# Access Compliance Report

## Public Rights-of-Way

### (Curb Ramps)

Intersection ID: 14459	Main Street: CROSS_CREEK_LN	Cross Street: FARM_POND_LN	Location:	N
ADA ID: C6D828C24962	Ramp Type: BlendTrans1	Initial Pass/Fail: Fail	Overall Compliance: No	Severity Score: 10

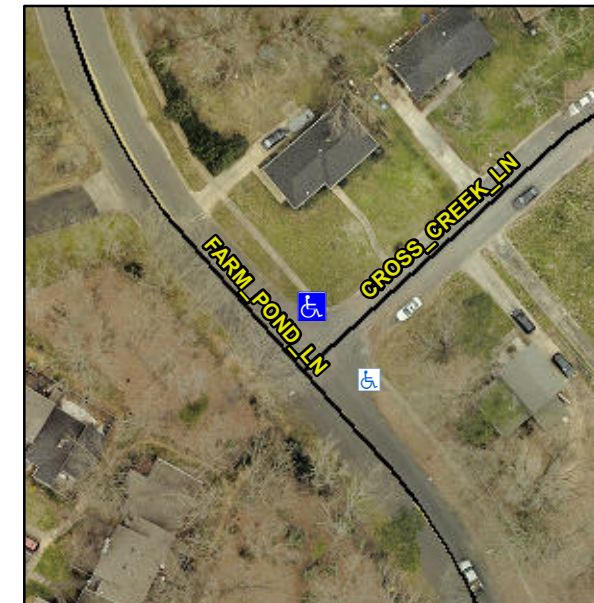
**Not Found, R304.5.1, R304.5.3**

Compliance	Description	Data	Compliance	Description	Data
N/A	Ramp Length (in)	80.0	Yes	BlendTrans Slope (%)	3.3
No	Ramp Width (in)	41.0	No	BlendTrans XSlope (%)	2.5
N/A	Flare Type LT	N/A	N/A	Flare Type RT	N/A
N/A	Flare Slope LT (%)	N/A	N/A	Flare Slope RT (%)	N/A
N/A	Flare Traversable LT?	N/A	N/A	Flare Traversable RT?	N/A
N/A	Landing Length (in)	N/A	N/A	DWS Provided?	N/A
N/A	Landing Width (in)	N/A	N/A	DWS Contrast?	N/A
N/A	Landing Slope (%)	N/A	N/A	DWS Length (in)	N/A
N/A	Landing X Slope (%)	N/A	N/A	DWS Full Width?	N/A
N/A	Landing Curb? (Y/N)	N/A	N/A	DWS Offset (in)	N/A
N/A	Shared Landing?	N/A			
N/A	Gutter Ponding?	N/A	N/A	Gutter Slope (%)	N/A
N/A	Gutter Lip Ht (in)	N/A	N/A	Gutter X Slope (%)	N/A
N/A	Painted X Walk1?	No	N/A	Painted X Walk2?	N/A
	X Walk 1 Direction	To SE		X Walk 2 Direction	N/A
	X Walk 1 Width (in)	N/A		X Walk 2 Width (in)	N/A
	X Walk 1 Slope (%)	5.5		X Walk 2 Slope (%)	N/A
	X Walk 1 X Slope (%)	1.4		X Walk 2 X Slope (%)	N/A

N/A	Ramp inside XWalk1?	N/A	N/A	Ramp inside XWalk2?	N/A
	Road Slope (%)	1.4		Clear Space?	N/A
	Road X Slope (%)	5.5	N/A	Clear Space to XWalk (in)	N/A
N/A	Any Obstructions?	N/A	N/A	Storm Grate/Utility Hazard?	N/A
	Obstruction Type			Storm Grate/Utility Type	
		N/A			N/A
			Yes	Surface Condition? (G/P)	Good
			No	Curb Slope (%)	15.6

**Remove & Replace Curb Ramp With Two New Directional Ramps or Equivalent.**
